CITY PLANNING COMMISSION

APPLICATION: 1. Negative Declaration
2. Special Permit to construct a 2,920 square foot church on 1.43± acres

LOCATION: South side of Lemon Hill Ave.--approximately 145 feet east of Logan Street

P83-004

Exhibit D

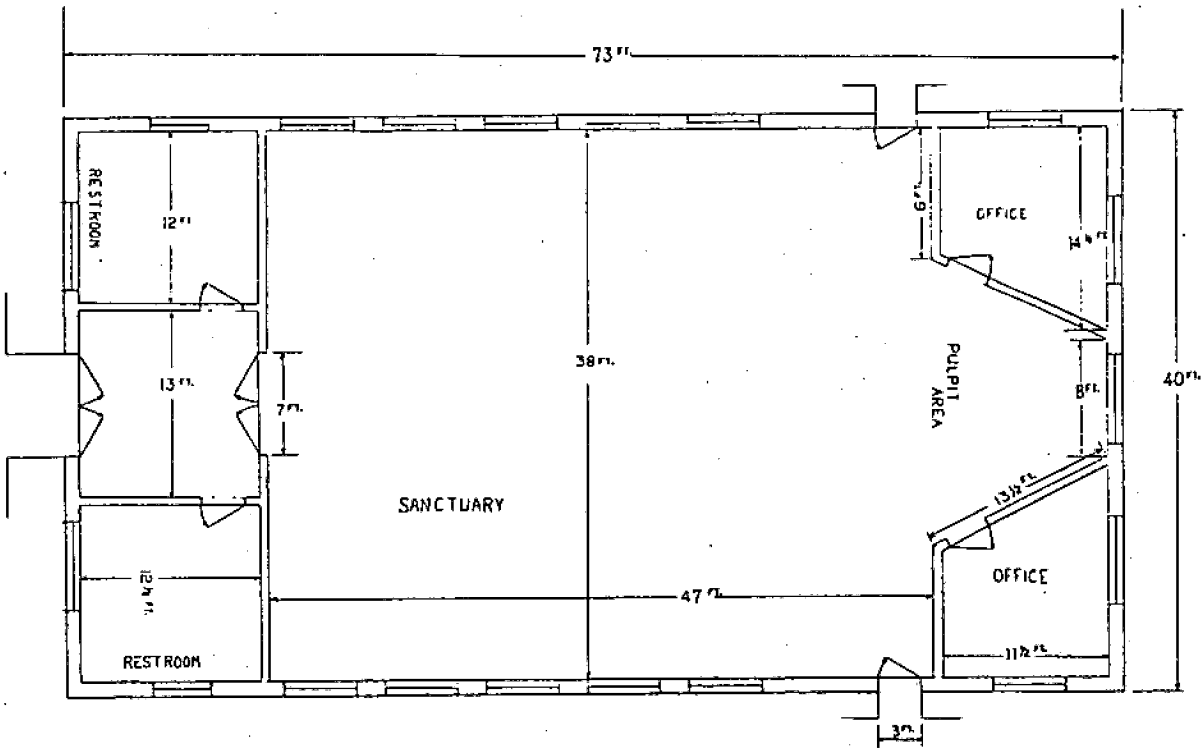
- b. Proposed driveway opening is too wide. Width of driveway should be 24 to 35 feet in width.
3. The subject site is located in a single family residential zone (R-1) with adjacent residential structures located to the east, a 52-bed convalescent home located to the west; and a drainage canal (Morrison Creek) and City park located to the south (Sim Park). At present, a cyclone fence runs along the boundary lines of the adjacent properties and the subject site. The Zoning Ordinance requires that a six-foot solid masonry wall be constructed between a non-residential development and existing residential property lines to the east and west (see Exhibit D).

- a. The applicant shall submit a revised site plan to staff for review and approval prior to the issuance of building permits. The revised plans shall detail an improved internal circulation pattern a minimum of 50 parking spaces and a 24-foot to 35-foot driveway opening as indicated on Exhibit D;

Exhibit A

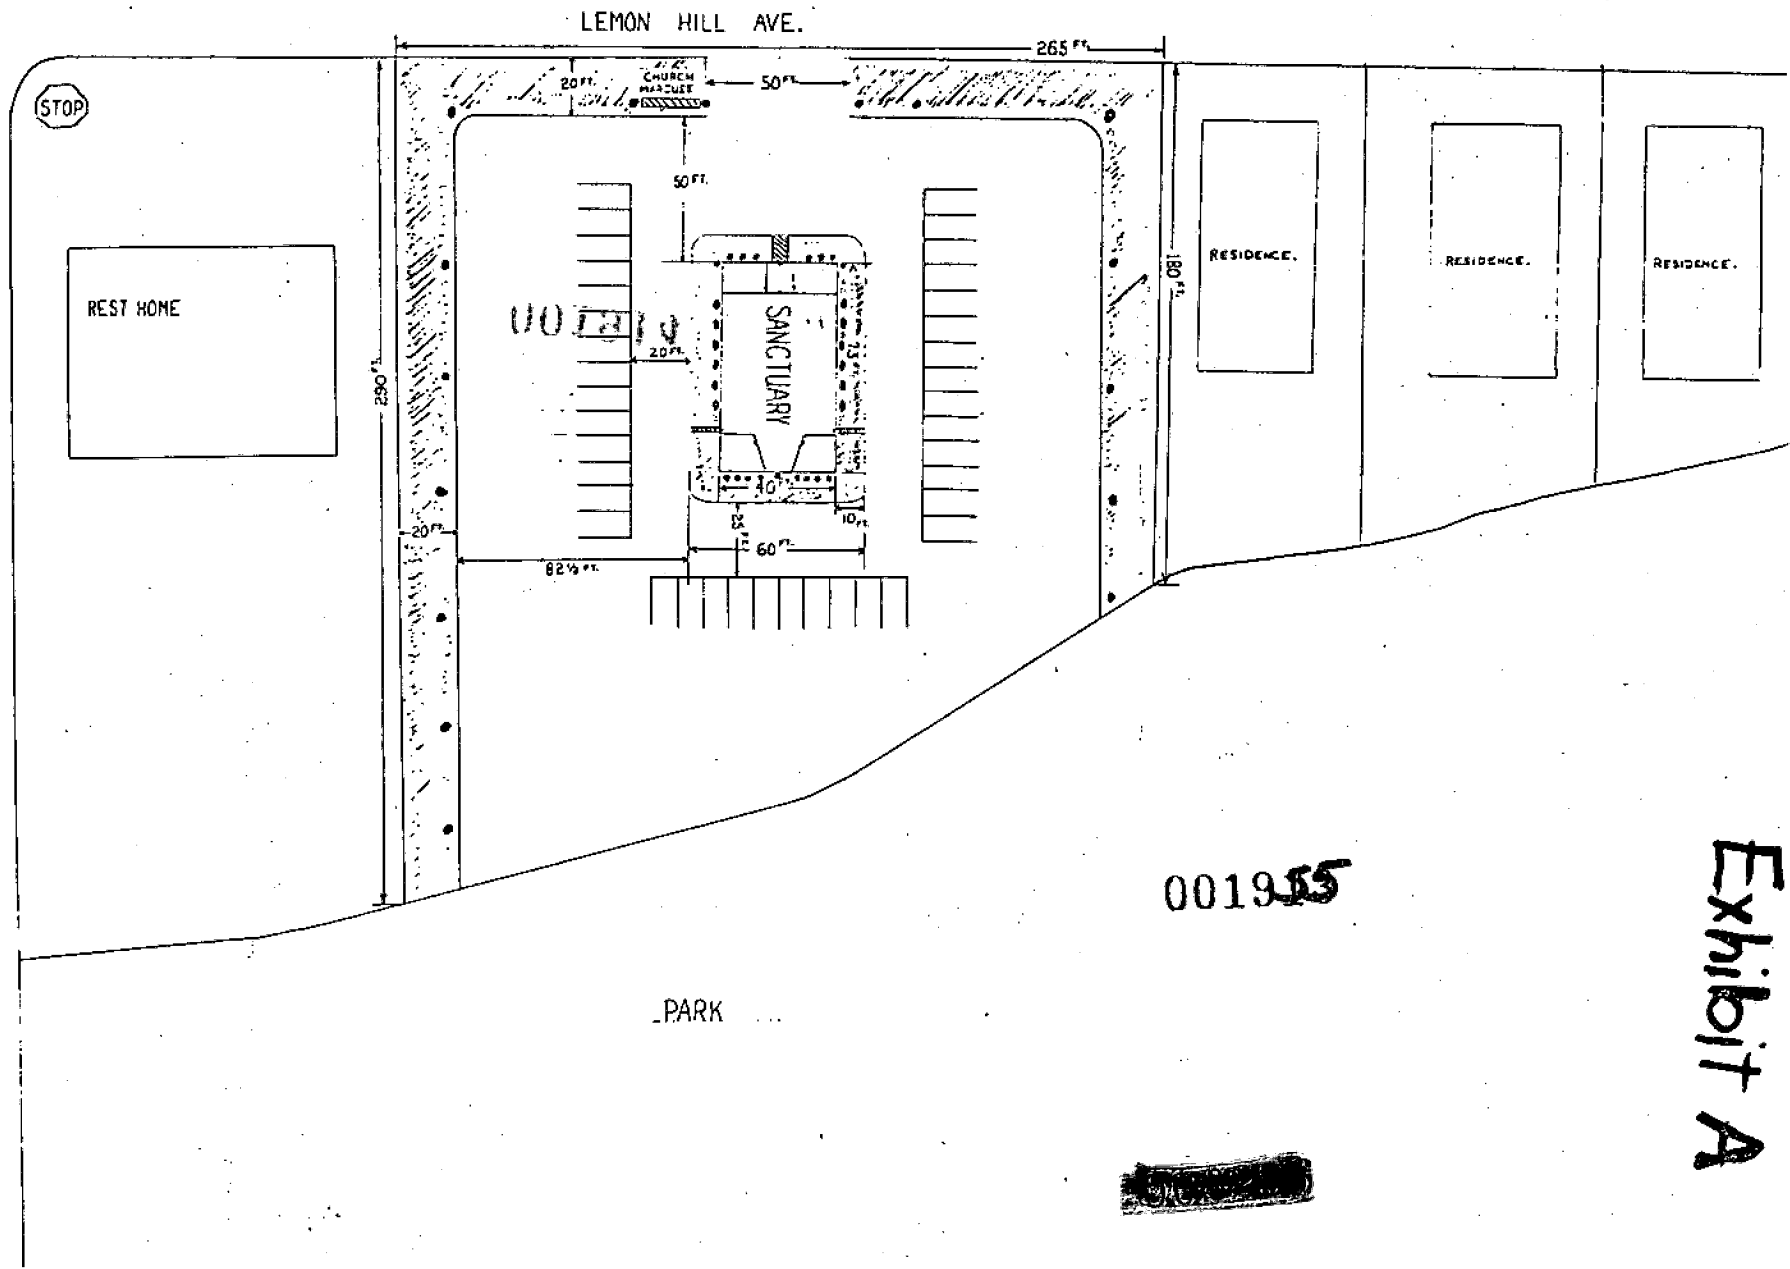
1. Staff has no objection to using the subject site as proposed by the applicant as the surrounding existing land uses, including single family residences and various public facilities such as schools, churches, day care centers and a neighborhood park, are compatible with the proposed use of a church. The site is also adjacent to Lemon Hill Avenue which is a 60-foot minor collector street with bike lanes.
2. The proposed site plans were reviewed by City Traffic Engineering. They had the following comments:
 - a. ~~800000~~ Circulation design is poor. Applicant will need to improve internal circulation design;

4. The applicant's site plan indicates a front landscape setback of 20 feet. This setback should be revised to conform with existing residential front setbacks along Lemon Hill Avenue which is 25 feet.

5. The applicant's site plan indicates 38 parking spaces for the proposed project. The applicant also indicated that the church will provide seating for 200 to 300 people. Based on a required parking ratio of one space for every six seats, the number of parking spaces required for 300 seats is 50 spaces, leaving the project short by 12 spaces.

In addition, staff has some concerns about the excessive amount (69%) of the site devoted to surfaced area. The applicant should consider leaving a larger portion of the site in landscaped area than what is shown on the site plan. The front setback should also have an undulated berm or combination berm and three-foot high low-profile solid masonry wall to screen the parking area and provide visual relief. Staff suggests a revised site plan similar to Exhibit D, which provides for the required parking, improves internal circulation and enhances the visual impact of the site.

7. Staff notes that the applicant has indicated on the site plans a detached sign of undetermined height and width in the front landscape setback. According to the City's Sign Ordinance, detached signs may not project into any required building setback area and non-residential signs in residential zones must meet certain requirements. Staff notes that any signage proposed by the applicant should comply with the provisions of this ordinance.

- b. A six-foot solid masonry wall shall be provided along the east and west property lines of the site up to the 25-foot front setback;
- c. The front setback shall conform to the existing residential setbacks along Lemon Hill Avenue;

- d. The applicant shall submit detailed landscape, irrigation and shading plans indicating a variety of shrubs, trees and ground cover for staff review and approval prior to the issuance of building permits. In addition, an undulated berm shall be provided along the entire front setback and shall be included in the landscape plan;
